**RE:      RESPONSE TO FURTHER ADVICE LETTER**  
**SECTION 13.2 OF THE DEVELOPMENT ASSESSMENT RULES**  
**70 & 78 KRAFT ROAD, PALLARA QUEENSLAND 4110**

We act on behalf of Lanochy Pty Ltd ATF Lanochy Unit Trust, the Applicant in relation to a Development Application lodged with Brisbane under the *Planning Act 2016* (the Planning Act) over the above land seeking a Development Permit for Reconfiguring a Lot (2 into 48 lots).

On 15 July 2026 we received Further Advice from Brisbane City Council under Section 35 of the *Development Assessment Rules* (DA Rules). We now respond to all of the information requested.

Figure 1 – realigned pathway and crossing at Road 3 intersection

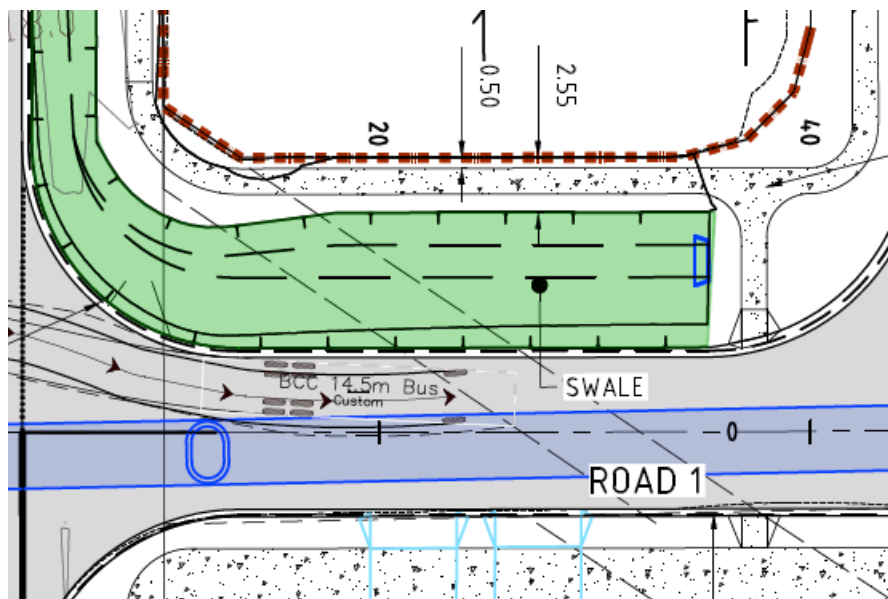
- 1) *From reassessment, it is apparent that there is insufficient space to construct the footpath along Kraft Road to the new neighbourhood road. As the footpath cannot cross the swale, its alignment near the intersection of Kraft Road and proposed Road 1 must run north-east adjacent to Lot 1 to the new local Road 3. To provide for this footpath connection, a wider verge will be required near the intersection meaning Lot 1*

is to be shifted slightly west. Lot sizes and layout will require amendment to allow for the proposed footpath connection.

- a) Provide amended plans in accordance with PO10 of the Stormwater code and PO4 of the Infrastructure design code that demonstrates the Kraft Road footpath connection realigned to connect to proposed Road 3.

**Response:** Amended plans have been provided to show a new footpath connection of the Kraft Rd footpath to Roads 1 and 3 so that it crosses the Road 1 swale at the culvert crossing located at the intersection of Road 3. This has been detailed on Plan B4621EA1\_DA1 CT01 Rev D.

To accommodate the change, the verge adjacent to Lot 1 has been widened by 1.7 metres. This has been achieved through a reduction in the size of lot 4 (from 450m<sup>2</sup> to 408m<sup>2</sup>). The change does not result in any additional sub-400m<sup>2</sup> lots and there is less than 1m<sup>2</sup> change to the overall average lot size as a result. Lot 4 does however change from a standard lot to a small lot and so a building location envelope has been added. All other lots are unaffected by this change.

Figure 2 – Typical Kraft Road Section

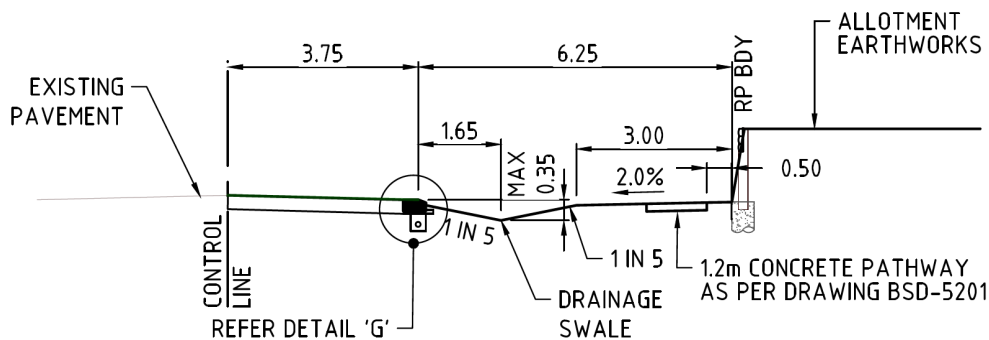
- 2) The proposed swale along the Kraft Road frontage must be of a sufficient size and capacity to convey flows. The current plans indicate a width of 3.25m proposed for the swale which at a 1 in 5 grade will permit only a 330mm deep swale. The submitted civil plans indicate the invert levels along the swale will be up to 600mm lower than Kraft

Road. This would require a minimum width of 5.4m for the swale to accommodate the required batters. This, in turn, will not leave sufficient space for footpath or street trees to be provided. Wider verges are required to be provided where the swale depth exceeds 350mm.

- a) Provide amended plans in accordance with PO10 of the Stormwater code and PO4 of the Infrastructure design code that addresses the above issues.

**Response:** The swale along Kraft Road is sized to convey flows and has been modelled in the hydraulic analysis provided in the Stormwater Management Plan. The swale has a maximum depth of 0.35m and this is now shown on the Typical Cross Section on the amended Plan B4621EA1\_DA1 CT08 Rev B (previously undimensioned).

Figure 3 – minimum 310mm cover achieved over culvert design

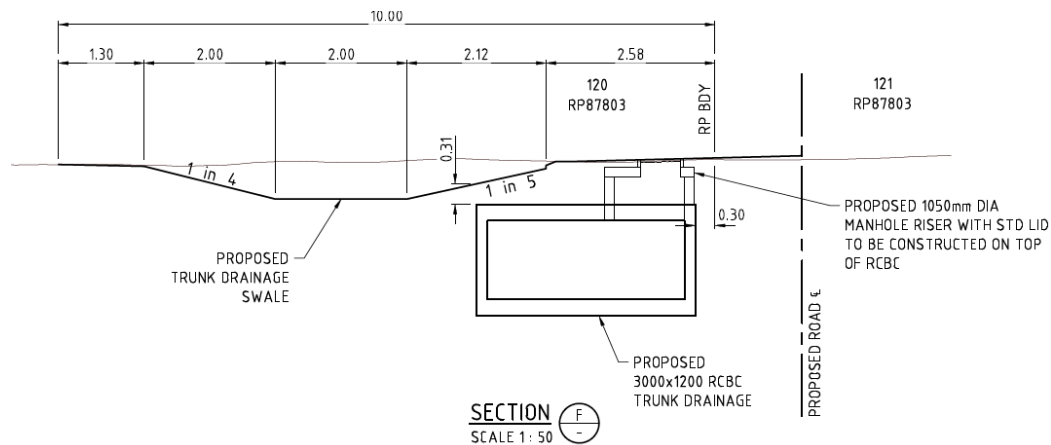
*Provide more detail on plans/sections through that downslope site to demonstrate, especially how manholes will work and that design is allowing the approved ROL on that land to be implemented and the trunk drainage to be constructed cost effectively.*

**Response:** The trunk drainage culvert alignment has been revised to a reduced offset of 300mm from the southern boundary of Lot 100 to maintain a minimum cover of 310mm over the culvert. Two sections are provided on Plan B4621EA1\_DA1 CS02 Rev B to show the proposed culverts achieve the minimum cover, noting these sections are taken at the lowest

point. In addition, proposed manhole risers have also been shown for Council's reference. To remove any doubt, it is confirmed that:

- All trunk stormwater infrastructure is wholly contained in Lot 100;
- The channel dimensions have not been revised (although this was supported by Council and can be investigated further at Operational Work stage if needed); and
- That the culverts used are the same as those referenced in the design drawings provided by Council.
